Approved Section 4.55 (.....2.....) Modification Application

Project
BARANGAROO STAGE 1B
PUBLIC DOMAIN
Modification S4.55

Drawing Title
WATERMANS QUAY
DETAIL PLAN - TREES

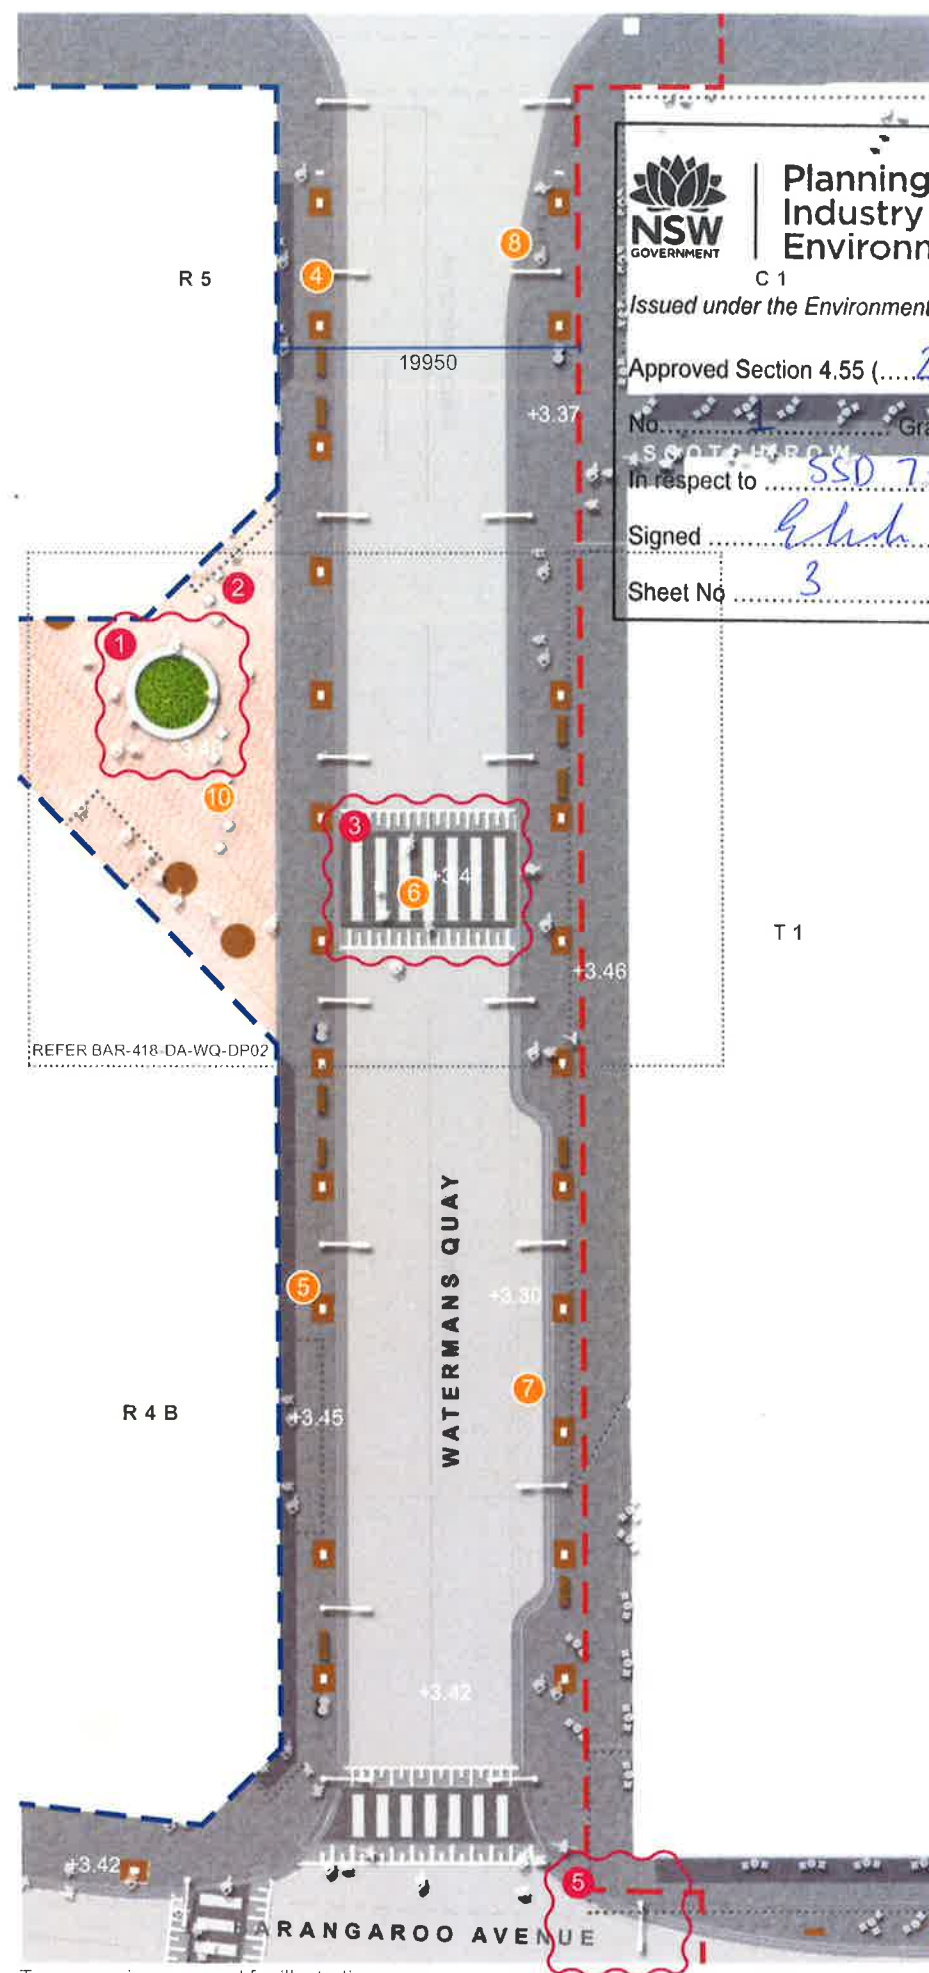
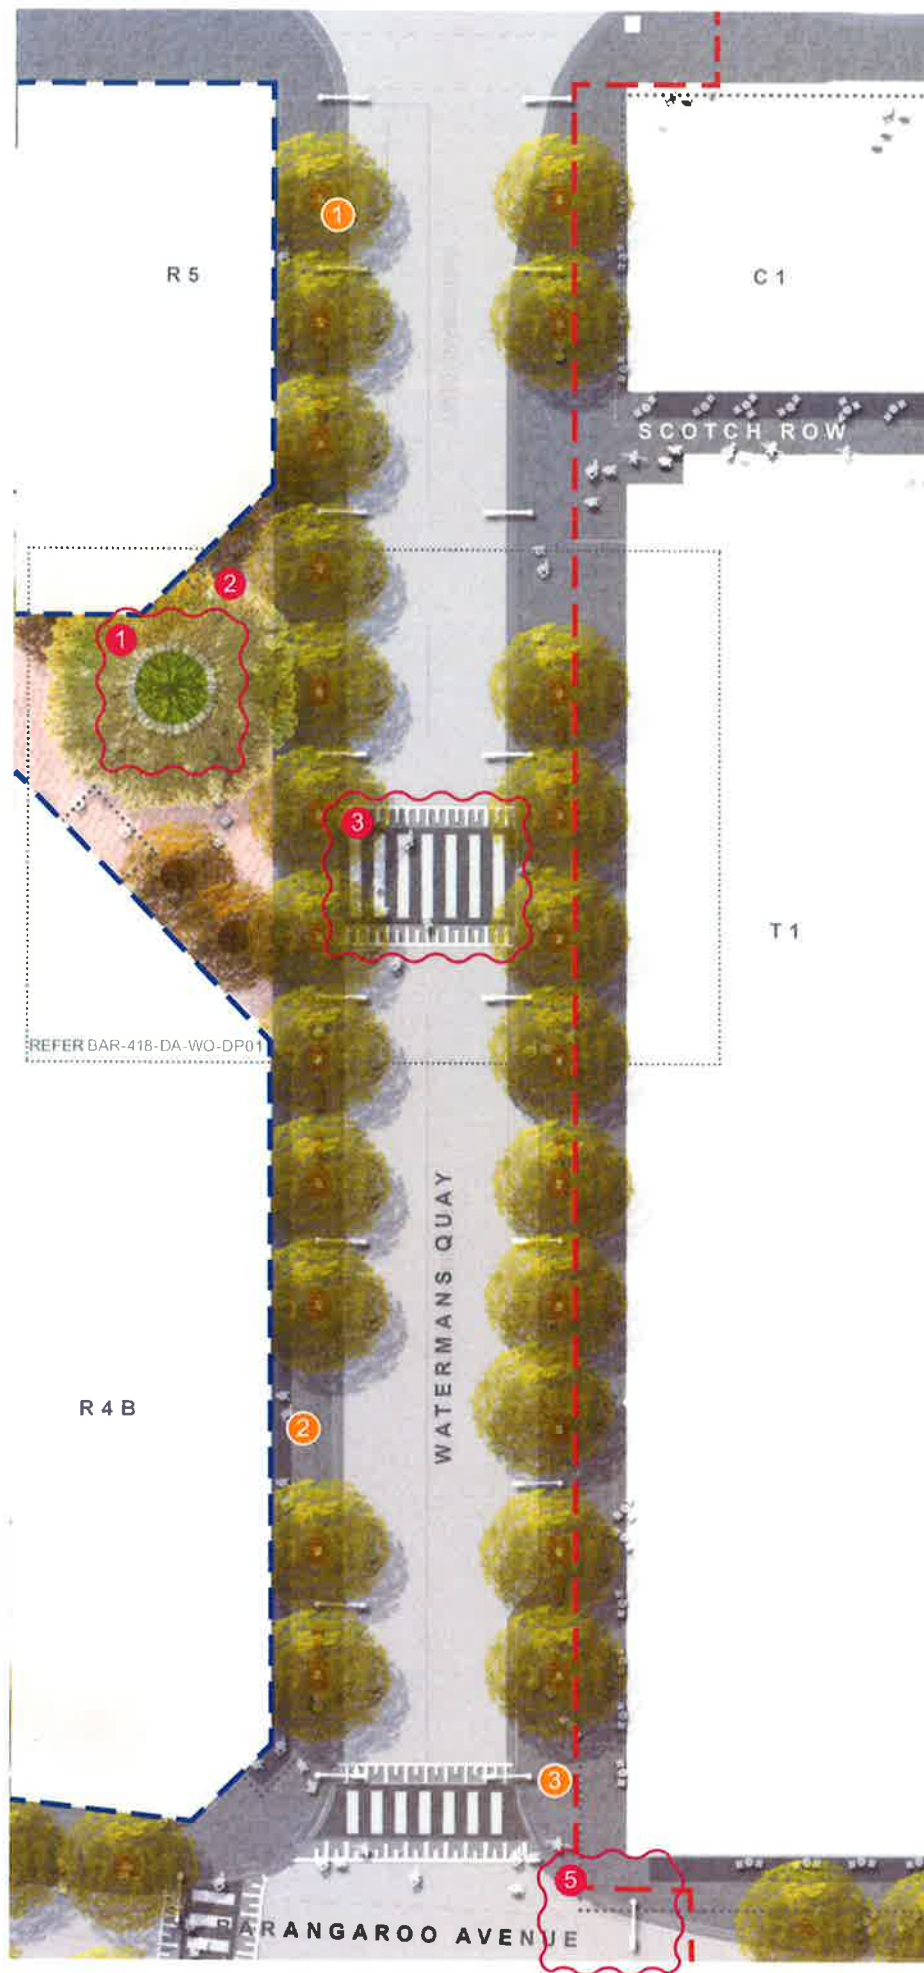
- LEGEND**
- Development application boundary
- Barangaroo South 1B boundary
- Proposed Modifications**
- Amendment cloud
- 1 Increase planting area within the park, change of geometry and remove 3no. access stairs. Shift ramps to align to buildings

- 2 Sandstone paving strip changed to City of Sydney paving along Hickson Park
- 3 Additional temporary tree as per consent requirement B29. Subject to Secretary's approval.

- 4 Remove timber top for Watermans Quay raised planter seating
- 5 Remove porphyry paving to City of Sydney transition as per consent requirement B23
- 6 Reduce size of raised crossing

- 7 Not in use
- 8 Deletion of pedestrian crossing
- 9 Relocated Fig tree to North raised planter
- 10 Change geometry of raised planter/reduce raised planter timber top and remove timber backrest

- 11 Stone stairs changed to concrete
- 12 Sandstone bollards changed to concrete, setout amended & delete bollards to East pier edge
- 13 Remove timber top for Sprit of Tasmania loading dock raised planter seating

- 14 Pier re-design: change to 3 tiers design
- 15 Stop porphyry paving at the top of the last Southern stair
- 16 No porphyry paving at Northern end of Wulugul walk

- 17 Stage 1A design modification to suit Stage 1 proposal. Subject to separate approval.
- 18 Removal of 2no. Celtis australis to respond pier amendment

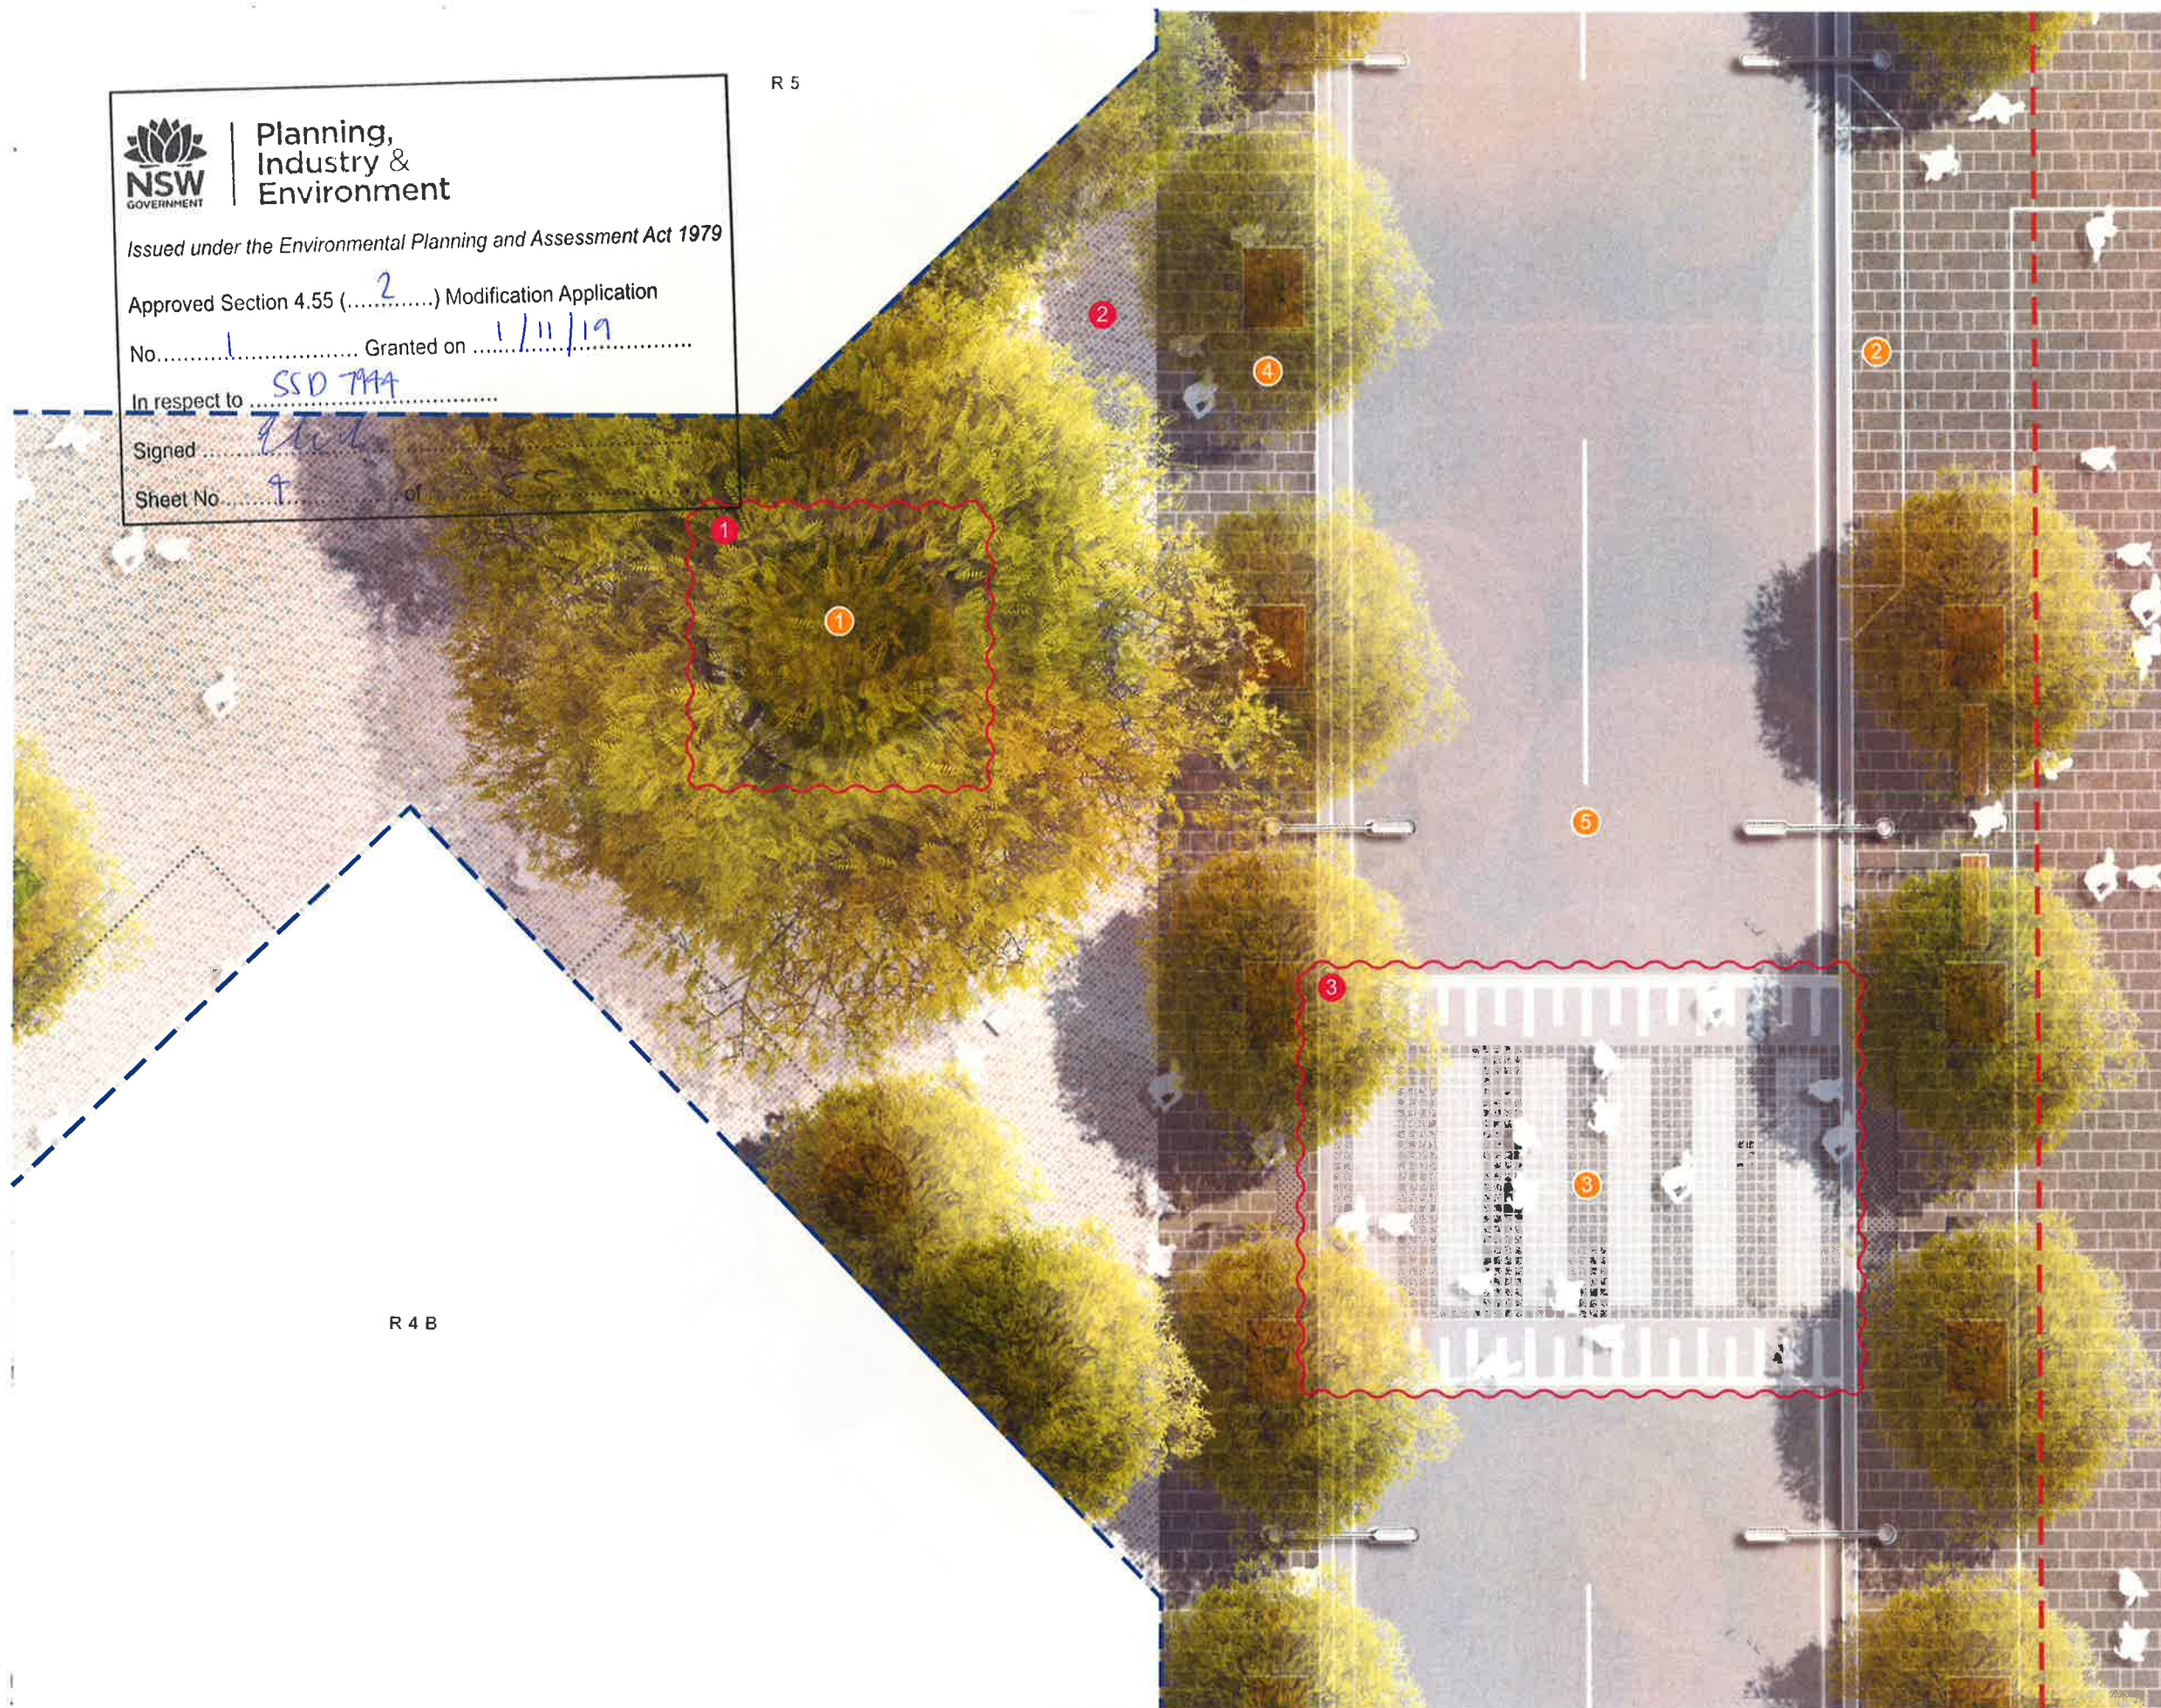
- Amendment cloud
- 1 Remove timber top for Watermans Quay raised planter seating
- 2 Remove porphyry paving to City of Sydney transition as per consent requirement B23
- 3 Reduce size of raised crossing
